Subject: LaSalle County Station Units 1 and 2
Application for Amendment to Facility
Operating Licenses NPF-11 and NPF-18
Appendix A, Technical Specifications
NRC Docket Nos. 50-373 and 50-374

LASALLE COUNTY STATION UNITS 1 AND 2

BACKGROUND AND DISCUSSION

Figure 1
RCIC Full Flow Test Return To Suppression Pool

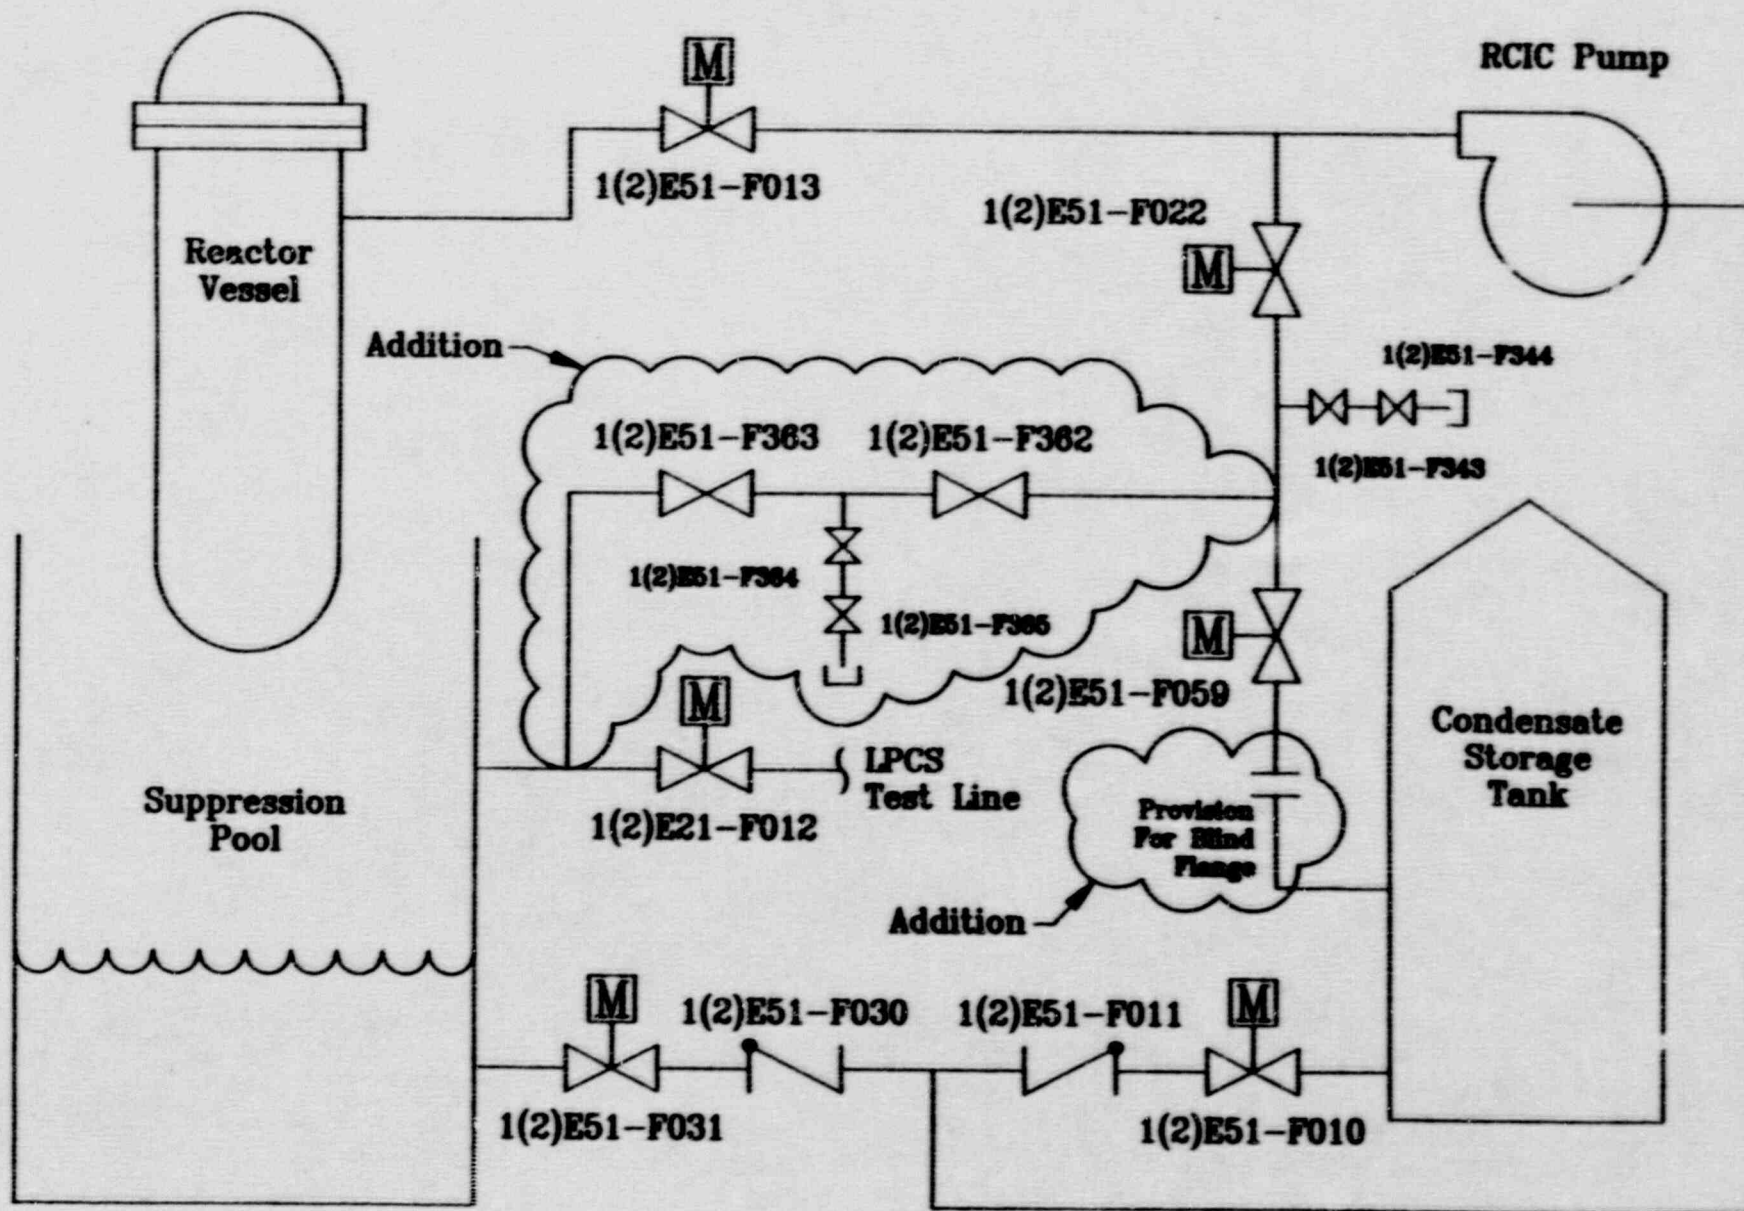
A result of these modifications, the technical specifications will have to be amended to add RCIC system full flow test valves 1(2)E51-F059, 1(2)E51-F362 and 1(2)E51-F363 to Table 3.6.3-1 "Primary Containment Isolation Valves." This amendment will help to ensure that primary containment integrity is maintained by instituting appropriate controls for operation and testing of these valves.

In the case of the RCIC system, which is normally in operation during post-accident conditions, the first barrier is a motor operated valve. The second barrier is the RCIC system itself which is considered to be a closed loop system (UFSAR Table 6.2-21 note 28). The new full flow test line will connect the area between valves 1(2)E51-F022 and 1(2)E51-F059 (refer to Figure 1) to the primary containment. If the system is lined up to the CST, the isolation valves on the new line to be installed (1(2)E51-F362 and 1(2)E51-F363), must be considered to be primary containment isolation valves, and must be locked closed. If the system is lined up to the suppression pool with manual valves 1(2)E51-F362 and 1(2)E51-F363 open then MOV 1(2)E51-F059 must be locked closed with a blind flange installed downstream of valve 1(2)E51-F059. In this configuration, valve 1(2)E51-F022 will become a primary containment isolation valve, and valve 1(2)E51-F022 will have a water seal on the outboard side. Therefore a water leak test is appropriate being consistent with similar configurations and UFSAR Table 6.2-21 note 29.

Under the proposed amendment the RCIC system will be allowed to conduct full flow tests either to the CST or the suppression pool. To maintain primary containment integrity only one test path will be in service at a time. Footnotes will be added to Table 3.6.3-1 to indicate that the primary containment isolation boundaries vary depending upon which flow path is being used (Refer to Figure 1).
